MEMORANDUM FOR: R. J. Mattson
FROM: NRR Technical Review Group
SUBJECT: UPDATED STATUS OF PROPOSALS FOR ACHIEVING
COLD SHUTDOWN FOR TMI-2

COLD SHUTDOWN OF TMI-2 USING WATER
SOLID SECONDARY IN STEAM GENERATORS

COMMENTS ON POSSIBLE OTSG DESIGN
LIMITATIONS RELATING TO
WATER SOLID OPERATION

FIGURE 2
 (NOTE: DESIGNER'S OFFICE FILE (4121))
 SILENT TERM - STEAM GENERATOR

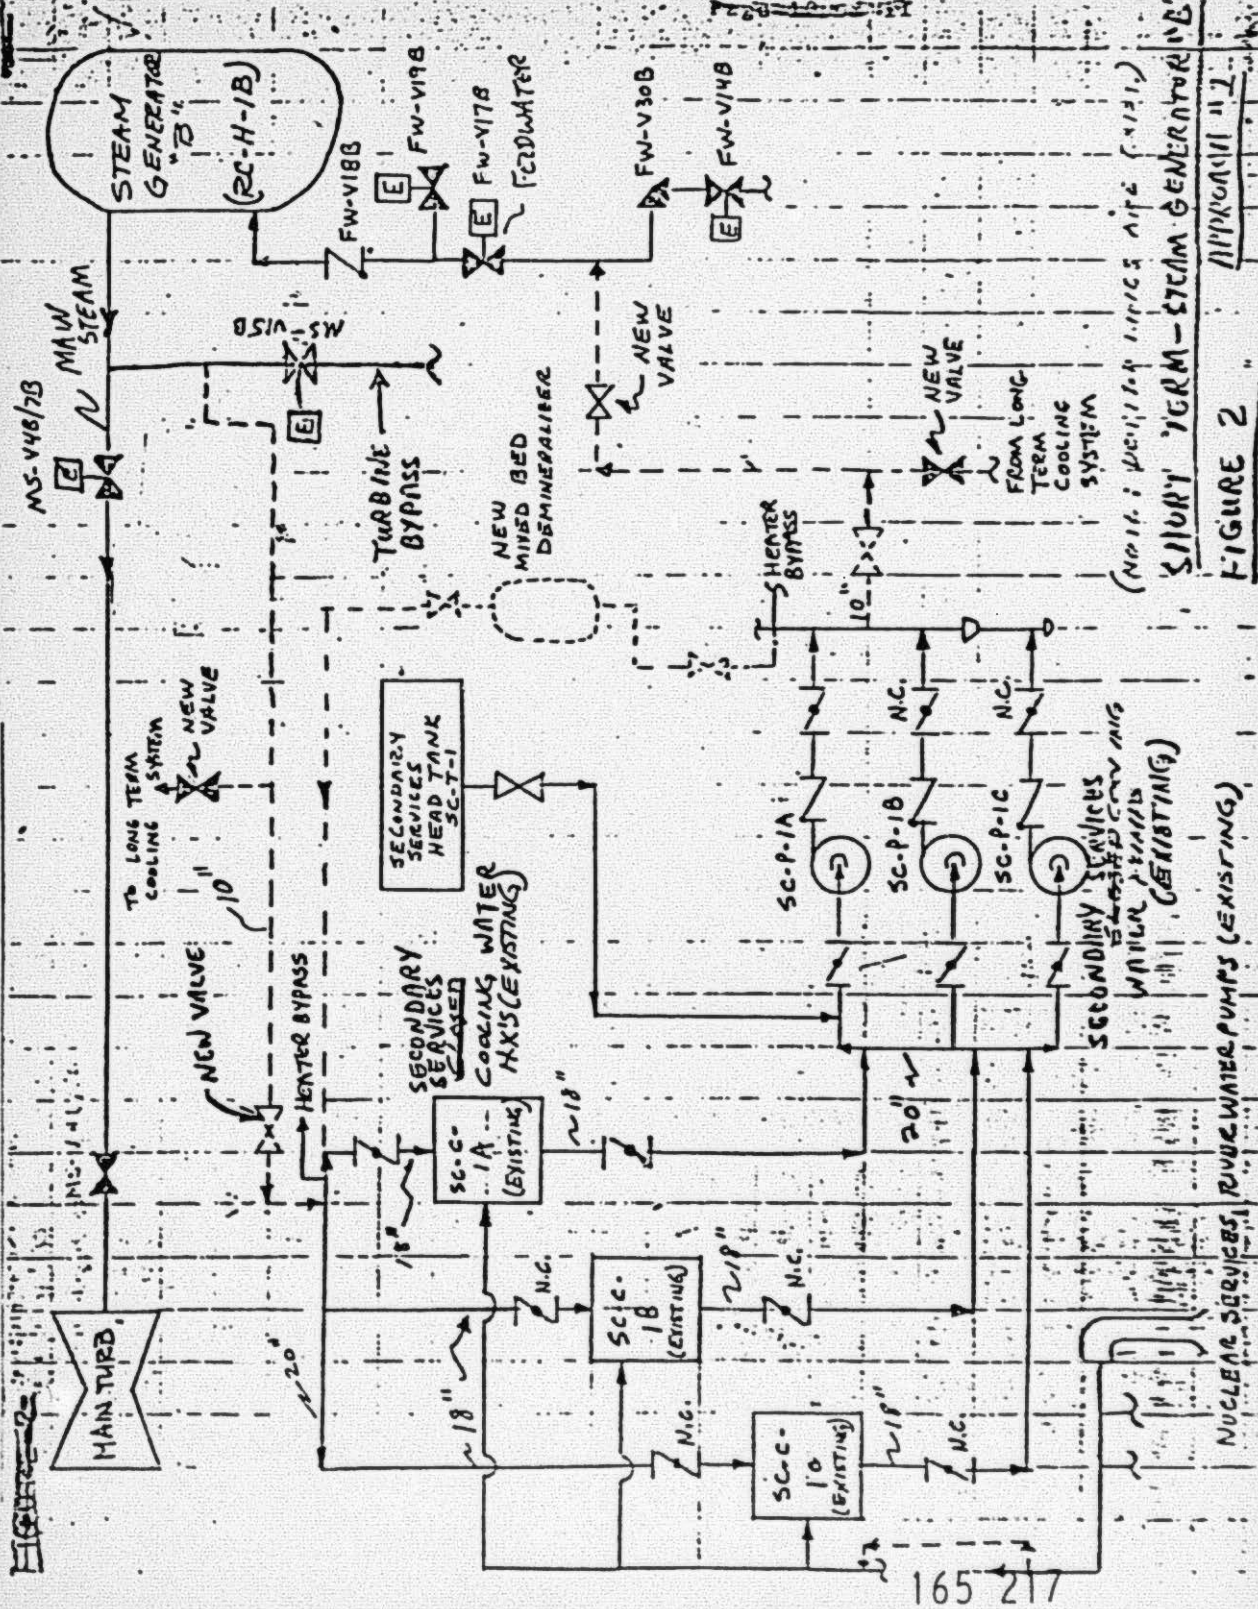
During the meeting with Burns & Roe on April 13, 1979, several shortcomings of the short term steam generator B (Approach #1) modification were brought out. These were:

1. The secondary services cooling water heat exchangers should be limited to 150^oF inlet water from the steam generators to prevent damage to the tube sheets. The heat exchanger manufacturer would expect that 200^oF water would be acceptable for a short period of time, however, the tubes are not welded into the tube sheets and the higher than design inlet temperature could cause separation of the tubes from the tube sheet resulting in leakage. While there should be adequate recirculation in the system to prevent this occurrence, provisions will have to be incorporated into the design to limit this temperature.
2. Since the tubes are not welded into the tube sheets, there will always be some leakage between the primary and secondary side of the secondary services cooling water heat exchangers.

3. The pressure is higher on the steam generator side of the secondary services cooling water heat exchangers, therefore leakage is always out. This could result in releasing radioactive coolant into the mechanical, draft cooling towers basin by way of the nuclear services river water system if steam generator B leaks. Blowdown from the cooling tower would carry potentially radioactive water to the river.

Based on the shortcomings of the steam generator B short term Approach #1 modifications identified and the relatively short difference in time to fabricate Approach #2, it appears that it may be possible to go directly to a more leak tight modification with little compromise in completion time.

FIGURE 3

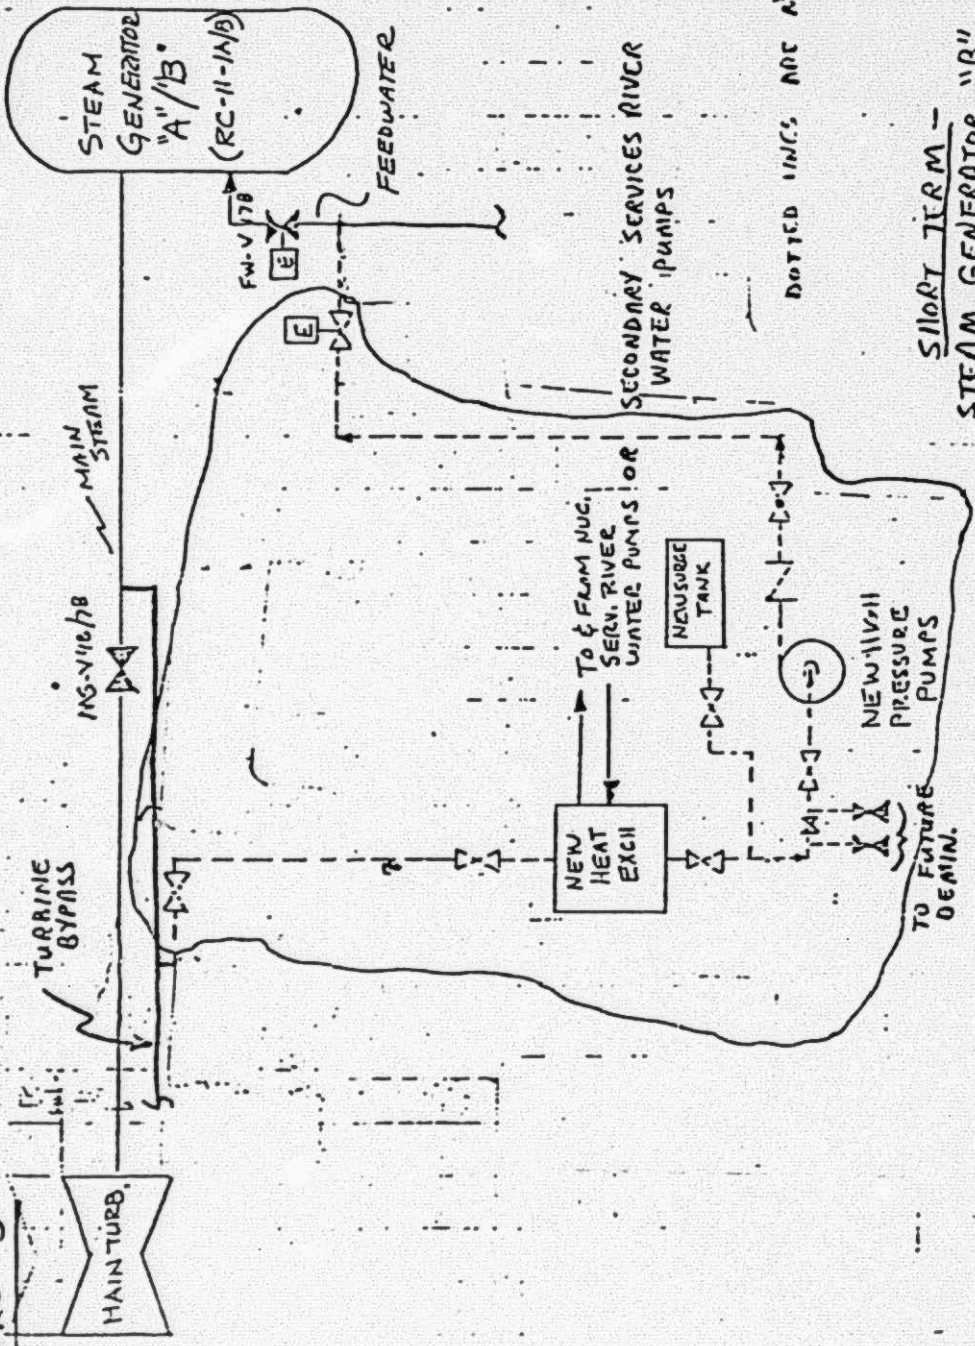
The advantages of this system would be 1) potential leakage would either be into the primary system instead of out or less than expected in Approach 1 and 2) high reliability for long term operation. If this approach is used the long term modifications to steam generator B described in section 3 would probably be eliminated. Whether approach 1 or 2 for short term steam generator B modifications is used is dependent

on the schedule for completion of the modifications. If the time difference is small, which is expected, then approach 2 is obviously preferrable.

FIGURE 1

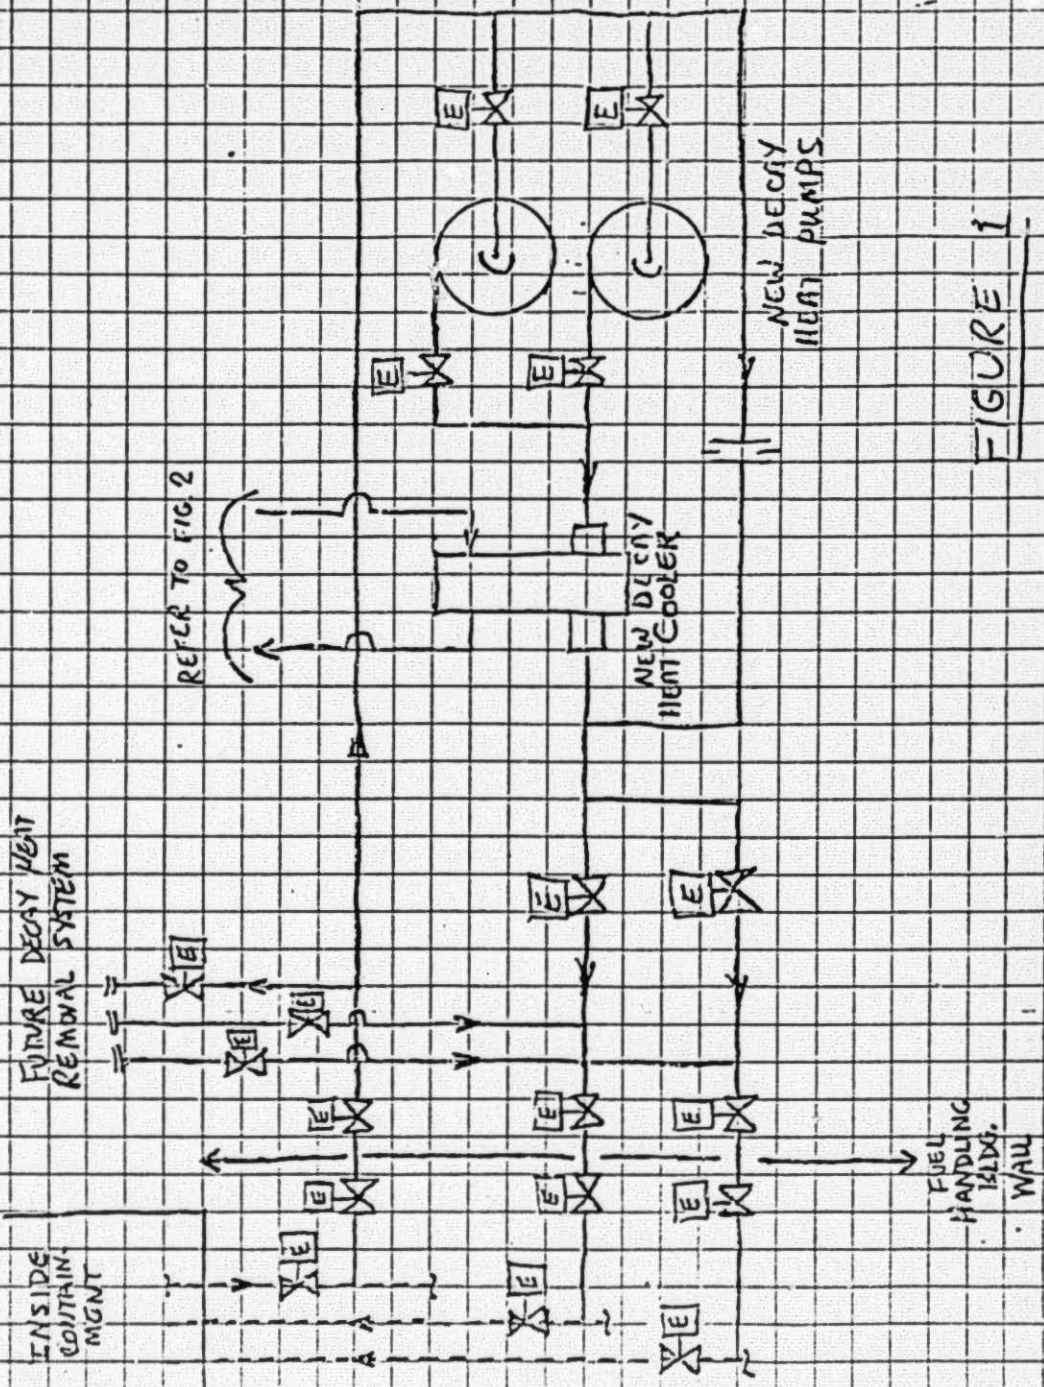
The design of this new decay heat removal system will require that the pressurizer level be maintained half full at all times. Alternatively, a backup makeup and pressure control system as described in Enclosure 8 would serve to satisfy this requirement.

SPENT FUEL PIT MODIFICATION (FIG. 1)

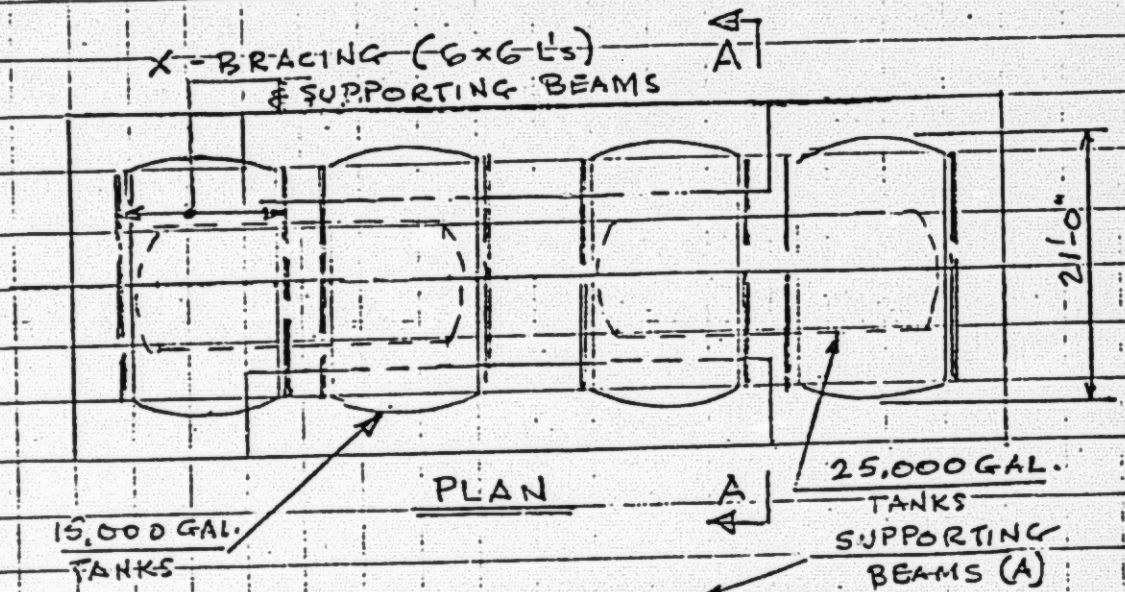
Figure 1 shows the proposed Spent Fuel Pit Modification. The purpose of the modification is to dispose of high level auxiliary building waste. Two tanks will be located at the bottom of the pit, 25,000 gal each. Their elevation will be adjusted by means of additional beams so that there is a clearance of approx. 1 foot between the outside of the tank and the concrete structure. Four additional tanks 15,000 gal. each will be suspended from beams (A) (See Figure 1), supported by the existing rails. The cross bracing, consisting of structural L's will be provided to stiffen the suspension structure.

The tanks were originally intended for middle and low level waste at another nuclear plant (see Q/C discussion for further details). The tanks will be prefabricated together with their hangers and their supporting beams and the entire assembly consisting of one 15,000 gal. tank, its cross-bracing and the supporting beams will be lowered into the pool. The tanks are fabricated with their saddies consisting of stiffened steel plates. At this time no information is available regarding piping and electrical connections.
